## CONDITIONS OF APPROVAL:

## Engineering - Final Plat Checklist

2018039-52-COF # XXXX first submittal 3-12-18 resub lot 135 gateway village.pdf

## 12. Green Infrastructure Easements

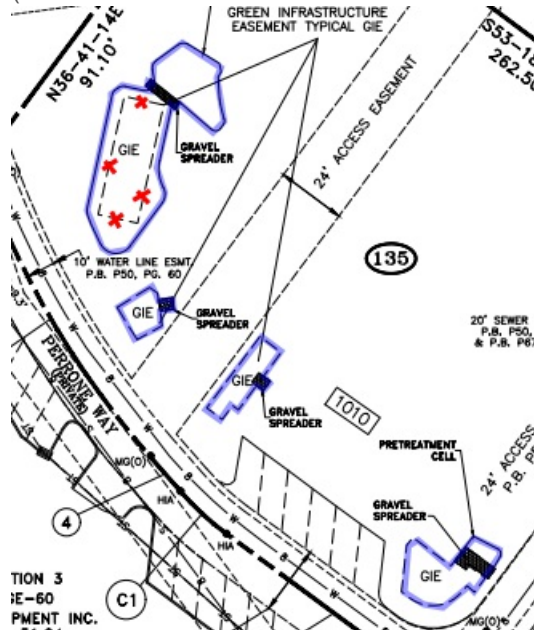
[joe.marlo@franklntn.gov](mailto:joe.marlo@franklntn.gov) Comment partially addressed, however some areas still appear to be outside of the GIE.

1. Applicant to revise GIE perimeter to clearly capture all green infrastructure elements (i.e. revise dashed 'GIE' line to match those shown in blue below).

2. Applicant to call out the pervious paver area as a GIE.
